13A Church Avenue, Mascot NSW 2020

Section 4.55(2) Modification to consent for DA-2024/10

On behalf of Iglu No. 216 Pty Ltd

25 March 2025

Figure 5: Proposed General Arrangement Plan - Ground (Bates Smart)

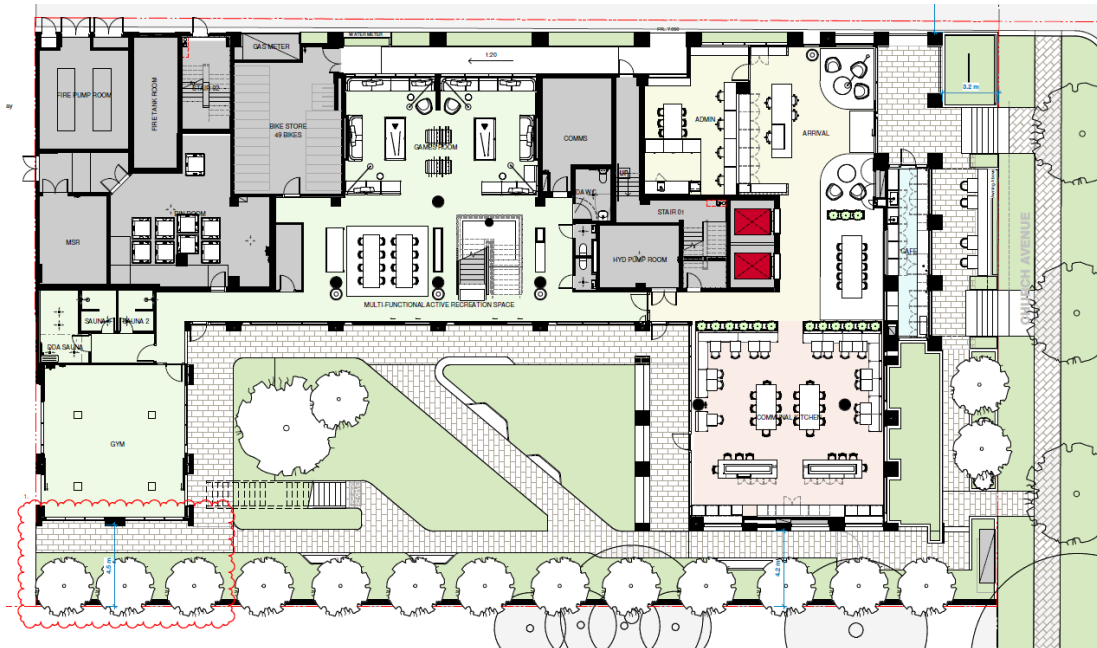
- South-east terrace on ground and first floor setback increased from 2.9m to 4.5m + 1m planter added around terrace perimeter to satisfy DA condition 22(b);
- Northern facade terrace widened in the north-south direction & 'work zone' extended to the eastern facade edge on level 1;
- Former leisure area on level 1 south-west terrace converted into an informal sports court with netting;
- Facade wall thickness increased to accommodate additional insulation; and
- Modify Condition 13 to permit the future café use to have detailed fit out and use approved either through later DA or complying development certificate. Refer to proposed wording in **Section 3.3** below.

Figure 6: Proposed General Arrangement Plan - Level 01 (Bates Smart)

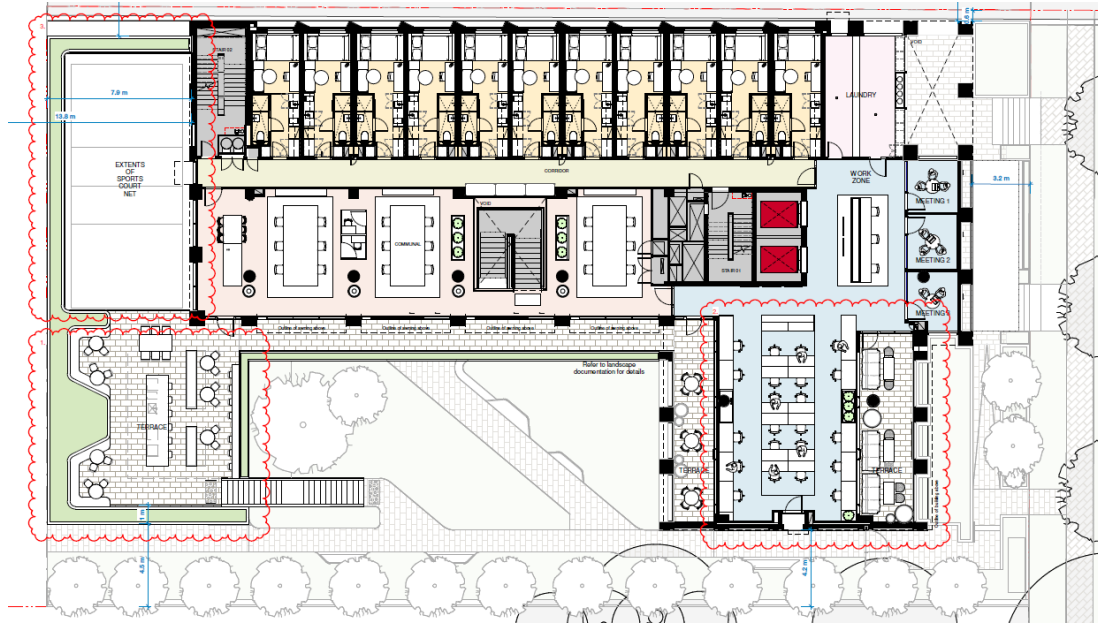
This subject modification proposes a further, very modest, increase in GFA of 9m², which will enable the study/co-working space on level 1 of the development to extend out to match the building footprint of the levels above and below. Whilst the study area will increase in size by 12m², the increased thickness of the façade to provide additional insulation has slightly reduced the GFA on all storeys, which means the net GFA increase is 9m². This represents a further FSR increase of 0.011%, to an overall maximum GFA of 8,201m² FSR of 4.086:1.
